Patentee: Kevin L. Parsons, et al.)
)
Patent No.: 6,749,317)
)
Dated: June 15, 2004)
)
Serial No.: 10/045,231)
)
Filed: November 9, 2001)
)
Primary Examiner: J. Ward)

REQUEST FOR CERTIFICATE OF CORRECTION

CERTIFICATE OF CORRECTION

FIG. 2

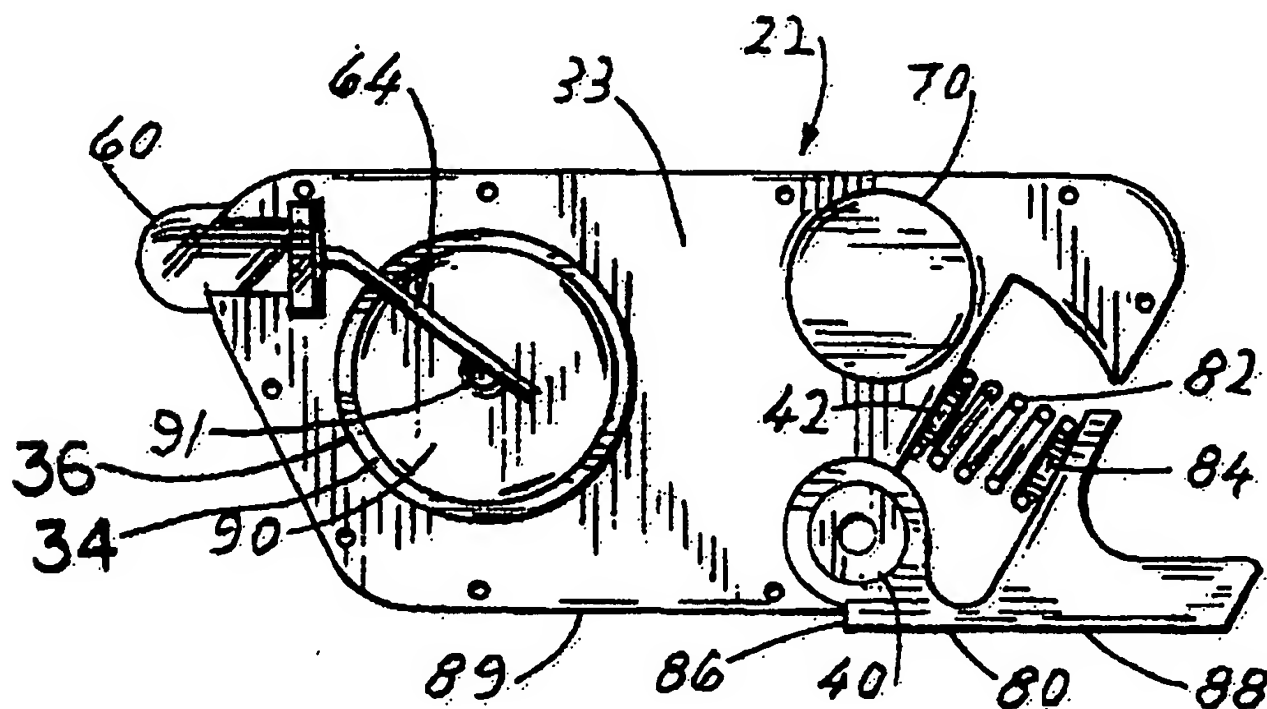
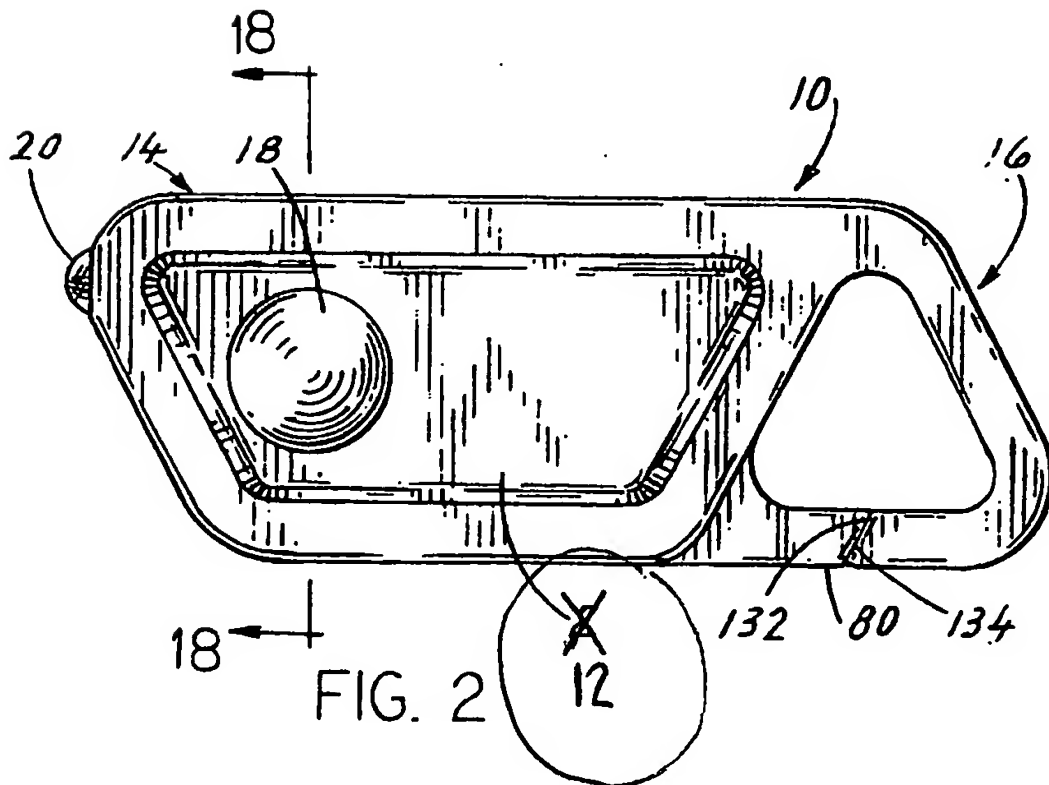
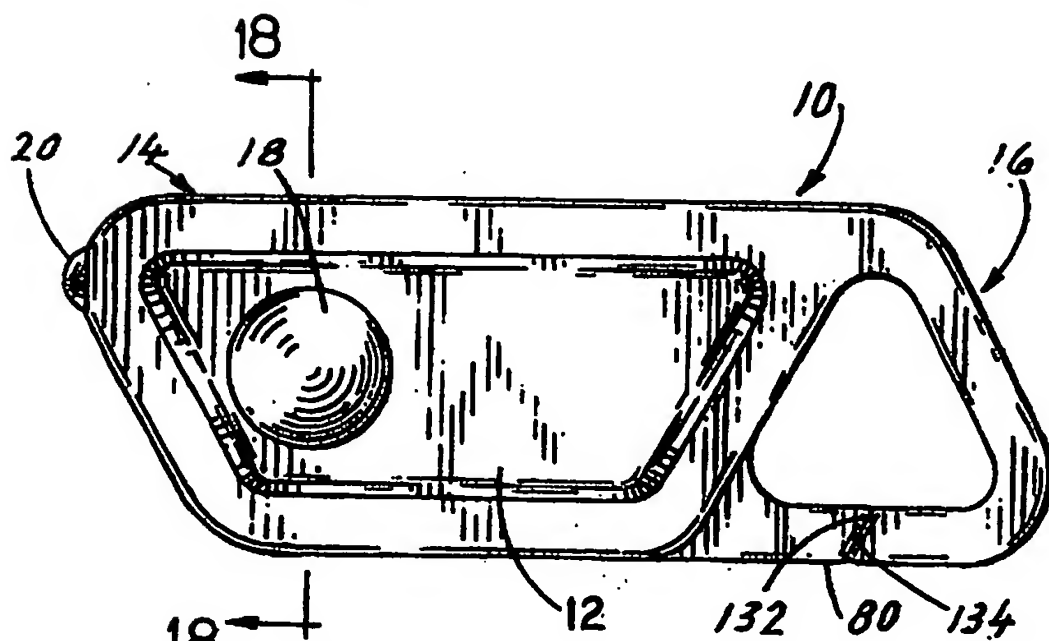
In the drawings, Sheet 1, FIG. 2, the reference numeral "2" should read --12--.

This corrects a typographical error. In the specification, reference numeral 12 refers to "a side cover" while the numeral 2 is not used. As corrected, FIG. 2 should therefore appear as follows:

A copy of the drawing sheet showing with the correction to FIG. 2 highlighted is attached hereto and is entitled "Marked-up Copy of Sheet for FIG. 2."

FIG. 9

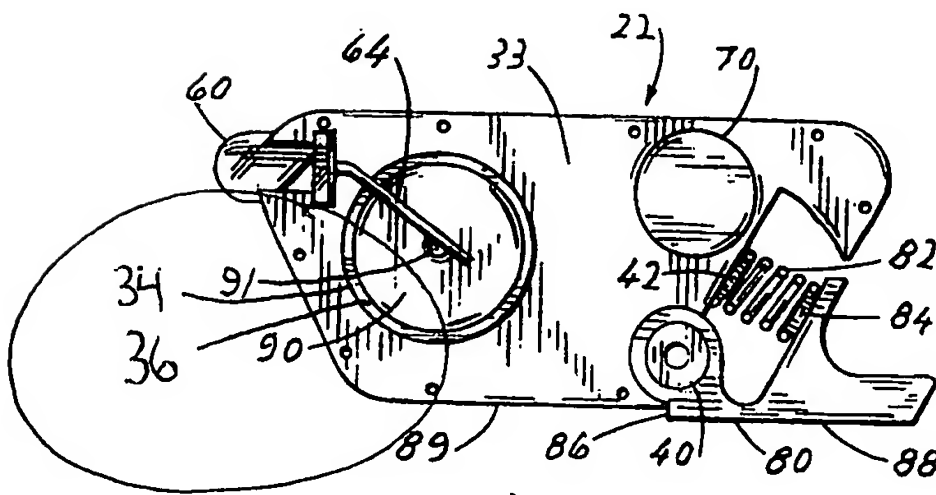
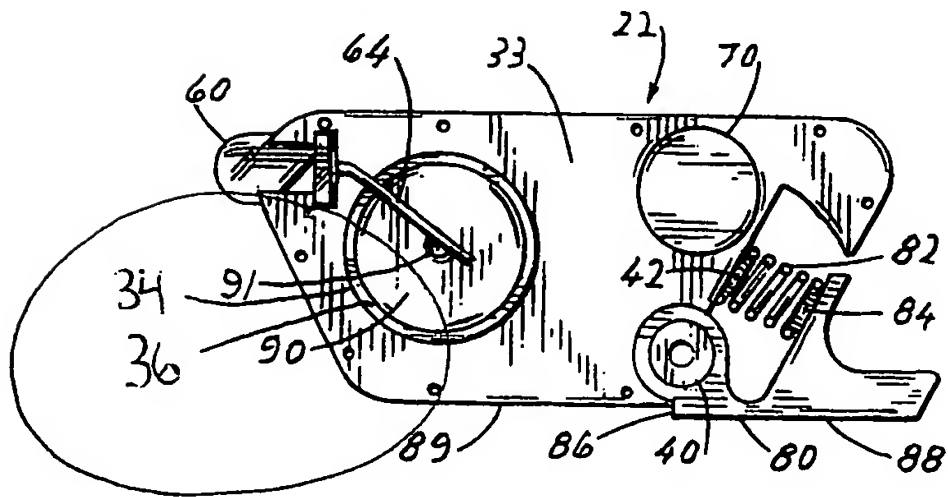
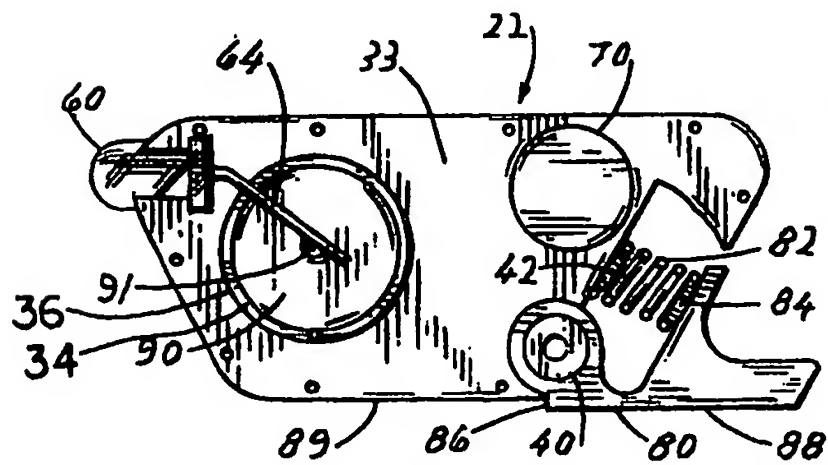
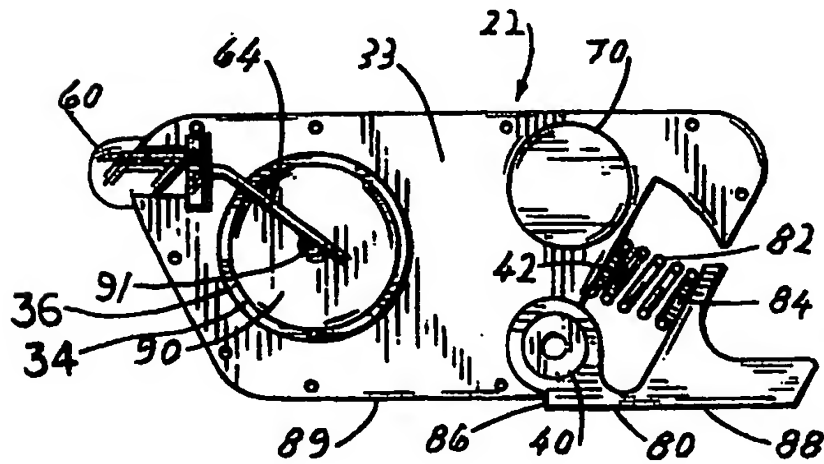
In the drawings, Sheet 3, FIG. 9, the reference numeral 34 and the related lead line should be applied to the counterbore.

In the drawings, Sheet 3, FIG. 9, the reference numeral 36 and related lead line should be applied to the terminus of the counterbore 34.

A portion of the specification that refers to FIG. 9 (see column 9, lines 1-10) identifies a counterbore 34 and a terminus 36. However, the current FIG. 9 does not have these reference numerals or lead lines for them. As corrected, FIG. 9 should therefore appear as follows:

A copy of the drawing sheet showing the corrections to FIG. 9 highlighted is attached hereto and is entitled "Marked-Up Copy of Sheet for FIG. 9."
